Department of Transportation

National Highway Traffic Safety Administration

Visual-Manual NHTSA Driver Distraction Guidelines for In-Vehicle Electronic Devices; Notice

[Docket No. NHTSA–2010–0053]

Figure 2: Drawing of Slide Presented by Toyota at NHTSA Technical Workshop¹³⁶

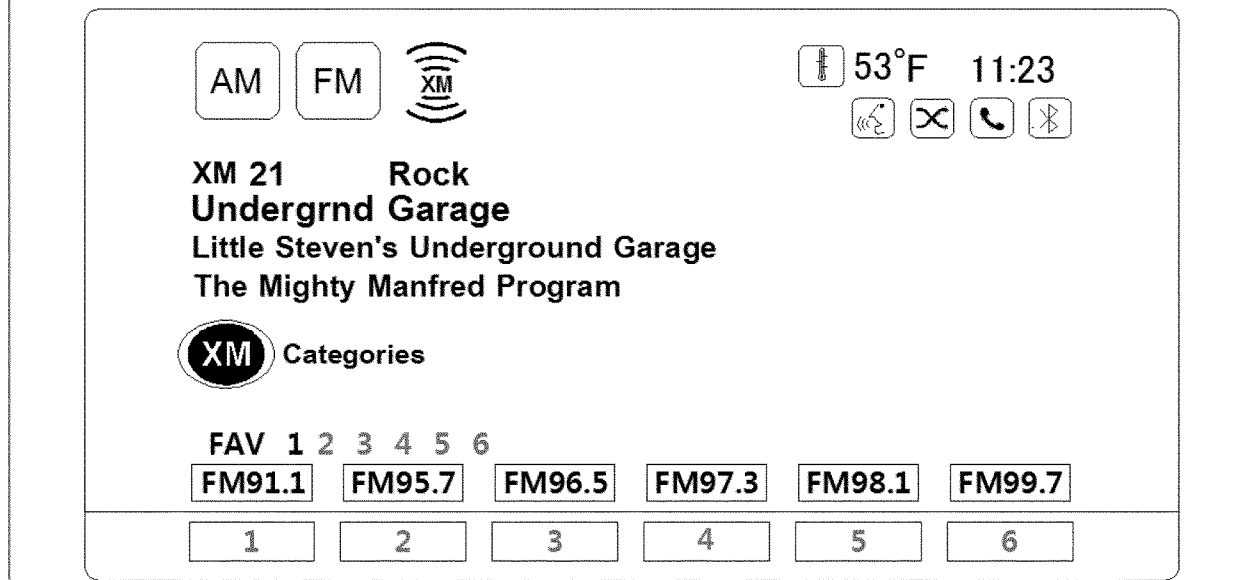
radio station program information (See Figure 2 below). He then asked:

five characters. So once we have the presets presented to the user, we can't give them any other information about what the radio is doing. If you pick any one element within this display, you quickly exceed a 30-character limit * * *¹³⁵

Where should the 30 character limit be applied to this display?

Mr. Foley then pointed out that the information conveyed by this display is easily grasped and that drivers do not have to read each individual letter to understand what is being transmitted by this display.
